URGENT: MEDICAL DEVICE CORRECTION

Design update to the Ascenda™ Intrathecal Catheter Models 8780, 8781, and 8784

09 May 2024 | 10:30 SGT

Figure 1: Picture of Ascenda catheter connecting to the pump

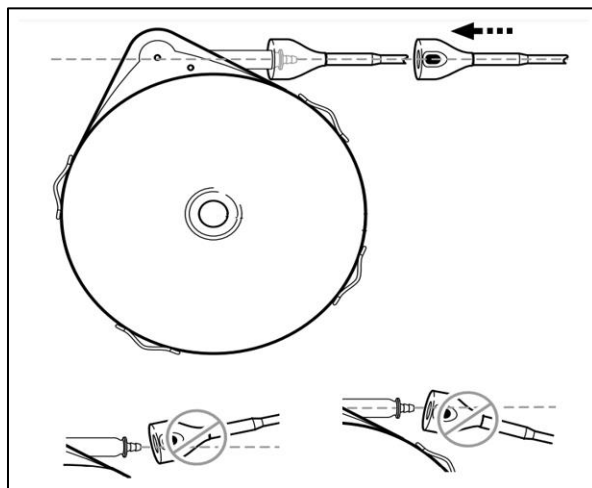
As noted in the Ascenda labeling, prior to implant, proper alignment and full engagement of the Ascenda catheter connector to the catheter port on the pump is critical in ensuring the catheter is properly and completely connected to the pump (refer to Figure 1). When connecting the Ascenda catheter connector to the pump, keep the connector in line with the catheter port and do not angle the connector. If connected at an angle, the Ascenda connector could detach after surgery, or an occlusion could occur at the connection site. Be sure to firmly secure all connections.
